**DECISION OF THE PLANNING ADMINISTRATOR**

**SUBDIVISION TENTATIVE PLAN / CLASS 2 ADJUSTMENT / CLASS 1 ADJUSTMENT / CLASS 2 DRIVEWAY APPROACH PERMIT CASE NO.: SUB-ADJ-DAP25-03**

# WOODSIDE TOWNHOMES TENTATIVE PLAN

**TENTATIVE SITE PLAN**  
SCALE: 1" = 20'

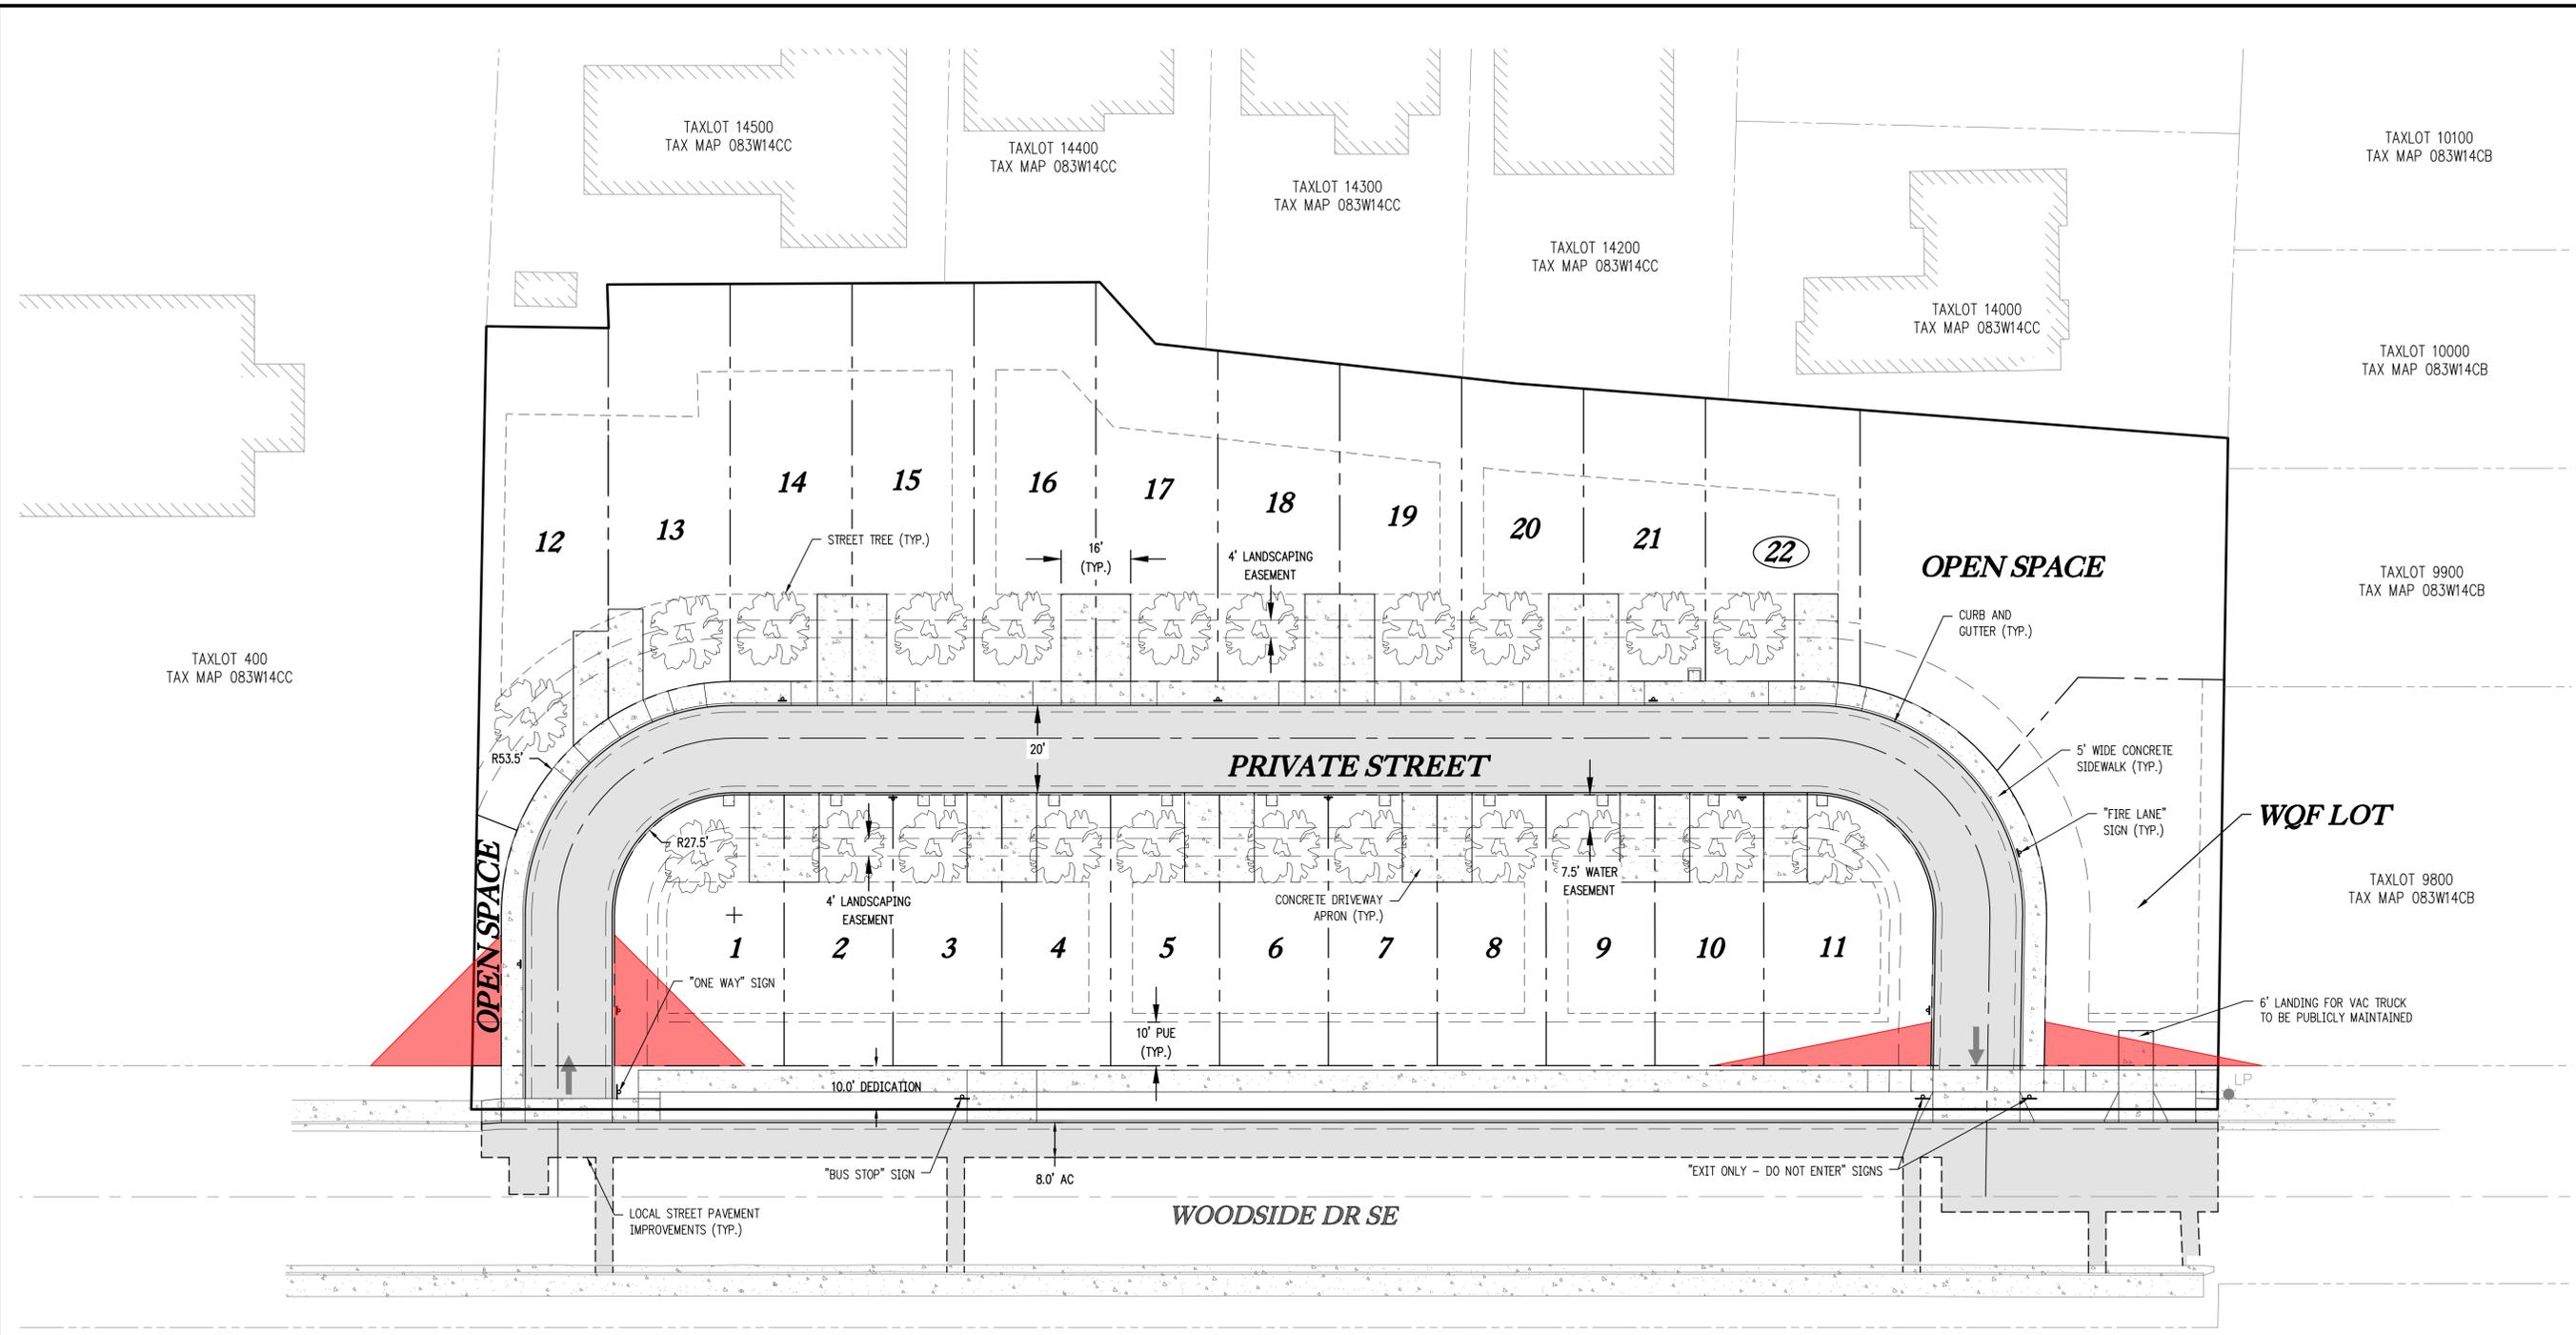
**Condition 1:** The private street shall be designed to include a minimum 26 feet of unobstructed access width adjacent to the fire hydrant. Where curb and sidewalk are present adjacent to the hydrant, a mountable curb may be provided for hydrant access.

**Staff Response:** As shown on the composite utility plan for the subdivision, a fire hydrant is proposed at the northeast corner of Lot 21 adjacent to the sidewalk; the improved travel lane width of the private street at this location between the curbs is 20 feet; and the width of the private street improvement (*including 20-foot-wide travel lane, 6-inch-wide curb, and 5-foot-wide sidewalk*) is 25.5 feet.
